**SOLICITATION AMENDMENT**

<b>Title - Sujet</b> 8.3-8.6m.Hydro Survey Workboats	
<b>Solicitation No. - N° de l'invitation</b> F7047-150011/B	<b>Amendment No. - N° modif.</b> 003
<b>Client Reference No. - N° de référence du client</b> F7047-150011	<b>Date</b> 2016-03-29
<b>GETS Reference No. - N° de référence de SEAG</b> PW-\$\$MC-024-25684	
<b>File No. - N° de dossier</b> 024mc.F7047-150011	<b>CCC No./N° CCC - FMS No./N° VME</b>
<b>Solicitation Closes - L'invitation prend fin at - à 02:00 PM on - le 2016-03-31</b>	<b>Time Zone</b> Fuseau horaire Eastern Daylight Saving Time EDT
<b>F.O.B. - F.A.B.</b> <b>Plant-Usine:</b> <input type="checkbox"/> <b>Destination:</b> <input checked="" type="checkbox"/> <b>Other-Autre:</b> <input type="checkbox"/>	
<b>Address Enquiries to: - Adresser toutes questions à:</b> Pilon, Chantal	<b>Buyer Id - Id de l'acheteur</b> 024mc
<b>Telephone No. - N° de téléphone</b> (819) 420-2914 ( )	<b>FAX No. - N° de FAX</b> ( ) -

**Bidder's Questions and Canada Responses**

**REQUIREMENT: SEVEN (7) 8.3 TO 8.6M ALUMINUM WORKBOAT WITH TRAILERS FOR THE DEPARTMENT OF FISHERIES AND OCEANS**

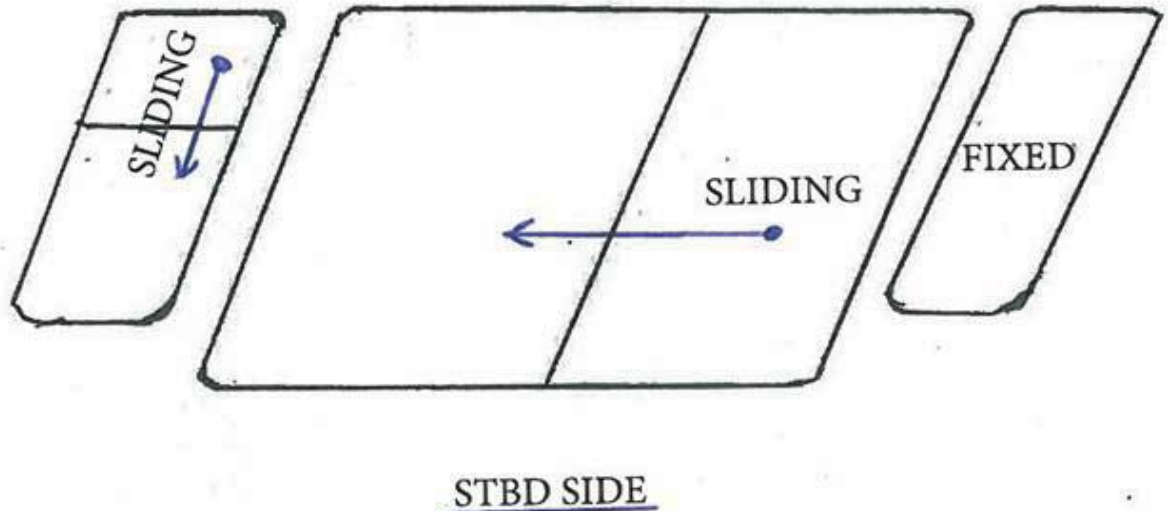
Reference 5.2.5.2, "Two (2) fixed side windows, in way of operator position". Can you confirm this is correct? Normally the operator requires an opening window to converse with crew on deck or shoreside dock.

Answer: 5.2.5.2 should have stated "Two (2) fixed side windows, one forward of the operator position and a second mirrored to the port side", please refer to window concept sketch provided in the TSOR.
